ECN/PCN No.: 4262

Product Description: Ceramic SMD Crystal	Abraccon Part Number / Part Series: ABM3	<input type="checkbox"/> Documentation only <input checked="" type="checkbox"/> ECN <input type="checkbox"/> EOL	<input checked="" type="checkbox"/> Series <input type="checkbox"/> Part Number
Affected Revision: V	New Revision: W	Application:	<input type="checkbox"/> Safety <input checked="" type="checkbox"/> Non-Safety

Mechanical Dimensions:

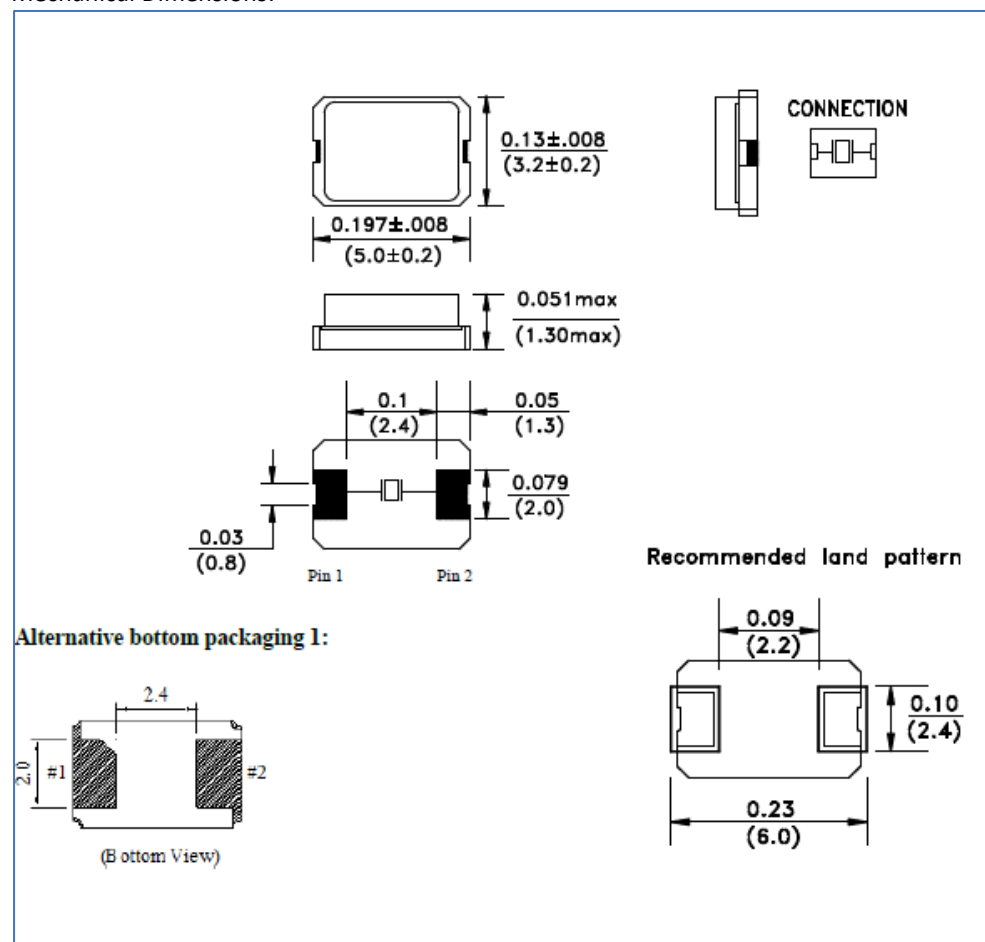
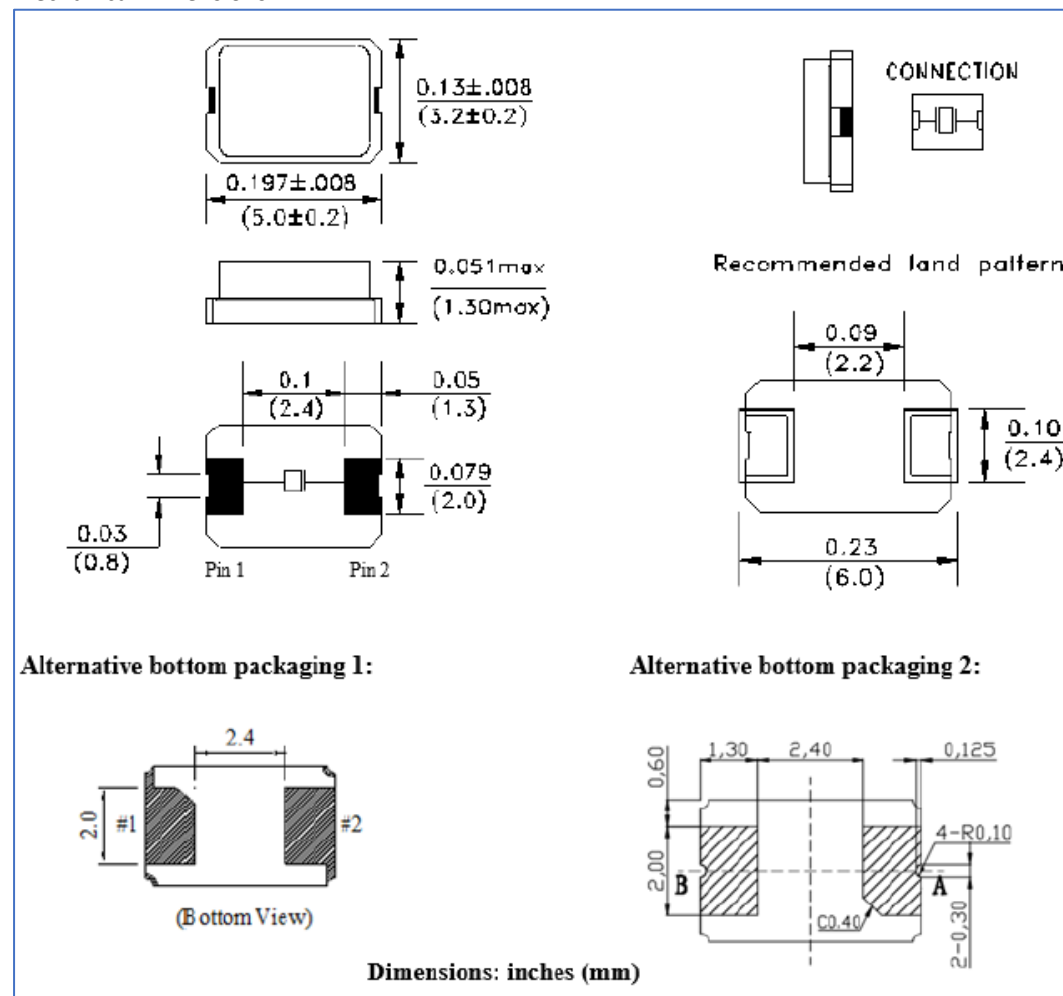
Abracon introduced additional manufacturing sources to ensure product availability and to be in a better position to meet long term customer demand. Added an alternative bottom packaging structure to reflect the product produced by all manufacturing sources.

Change Declaration:
The added bottom packaging structure does not impact the electrical performance of the device.
